APPLICATION NO.	FILING DATE	FIRST NAMED INVENTOR	ATTORNEY DOCKET NO.	CONFIRMATION NO.
10/516,955	12/06/2004	Bernd Gromoll	1454.1586	8626
21171	7590	01/04/2008	EXAMINER	
STAAS & HALSEY LLP			SCHEUERMANN, DAVID W	
SUITE 700				
1201 NEW YORK AVENUE, N.W.			ART UNIT	PAPER NUMBER
WASHINGTON, DC 20005			2834	
			MAIL DATE	DELIVERY MODE
			01/04/2008	PAPER

**Advisory Action  
Before the Filing of an Appeal Brief**

THE REPLY FILED ~~09 August 2007~~ <sup>29 Nov 2007</sup> FAILS TO PLACE THIS APPLICATION IN CONDITION FOR ALLOWANCE.

Note figure 1 of Philofsky, US 3271600 as shown below:

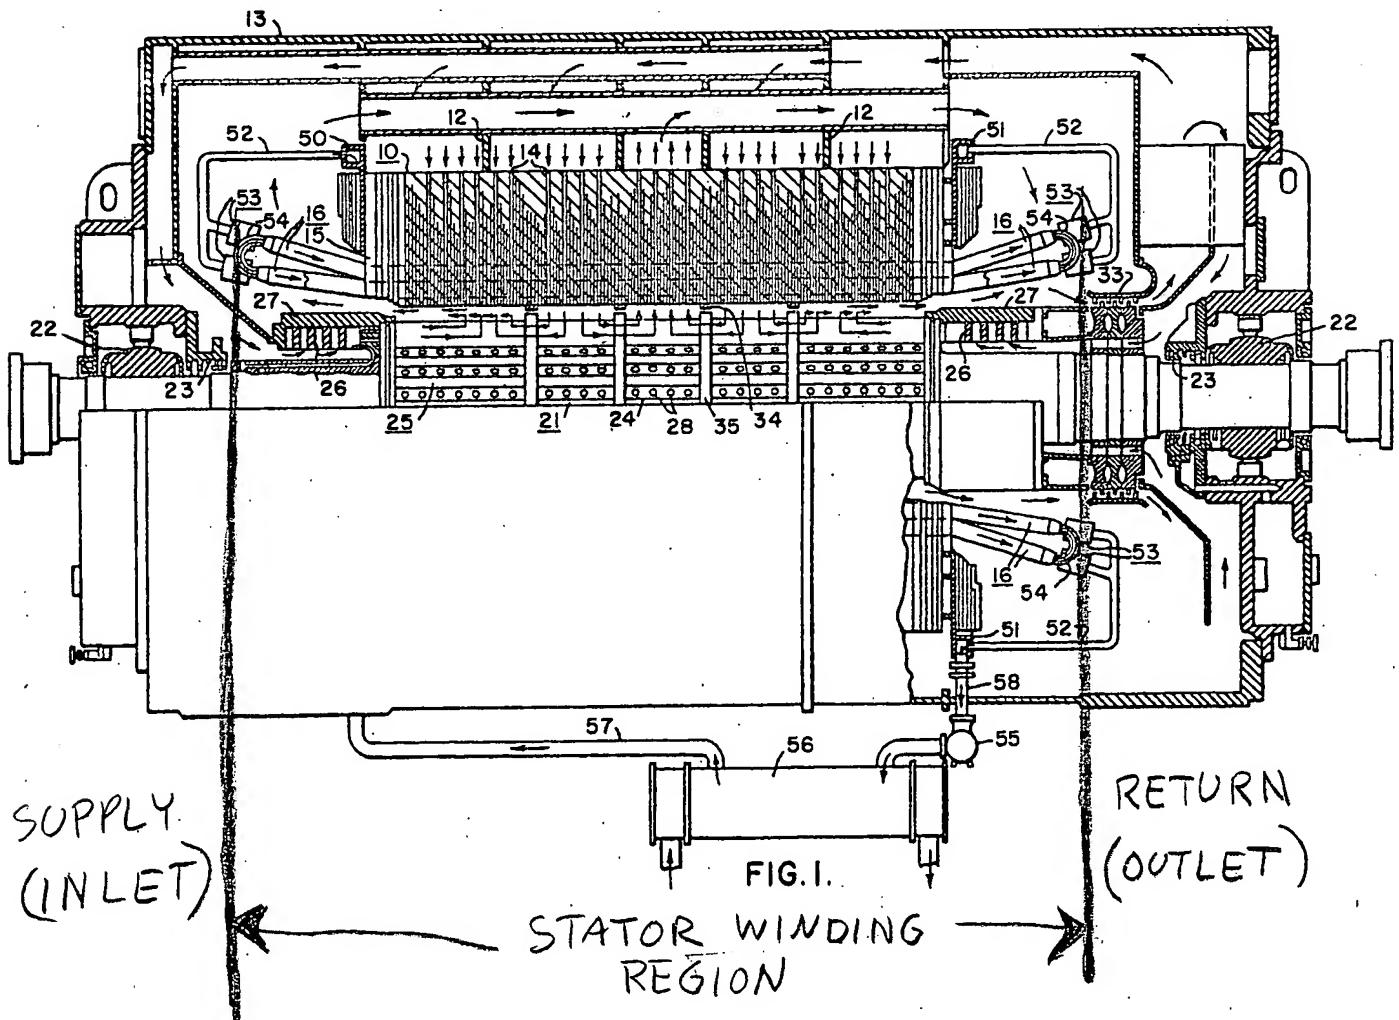
Applicant asserts that, "the statement that Philofsky, US 3271600 shows connectors 53 and each end of half coil 16" is incorrect. The Examiner disagrees with this assertion because the paragraph bridging column 3 and 4 of Philofsky, US 3271600 reads as follows:

In accordance with the present invention, the stator winding is cooled by a closed recirculating system for circulating coolant fluid through the ducts 18 of the stator coils. As shown in FIGURE 1, such a stator cooling system may include an intake manifold 50 at one end of the stator core 10 and a discharge manifold 51 at the opposite end. These manifolds may be annular passages extending circumferentially around the core and mounted at the ends of the core in any suitable manner. **The intake manifold 50 is connected by a plurality of insulating tubes 52 to the end of each half coil 16 of the winding, the tubes 52 being connected by suitable connectors 53 to the ducts 18 of the coil.** At the opposite end, similar connectors 53 connect the ducts 18 to insulating pipes 52 which are connected to the discharge manifold 51. The ducts 18 extend out of the coils at each end, and the end turn portions of the

conductor strands 17 of each half coil are connected to another half coil in the usual manner, as indicated at 54, (emphasis added.)

Thus, the cooling fluid inherently follows along the length of the stator and since the fluid connection points is at the ends of the stator windings which lie within the stator thus reading on the limitation of "a coolant supply line and a coolant return line at axial ends of the stator winding." Furthermore note figure 2 which shows cooling duct 18 with stator half coil 16.
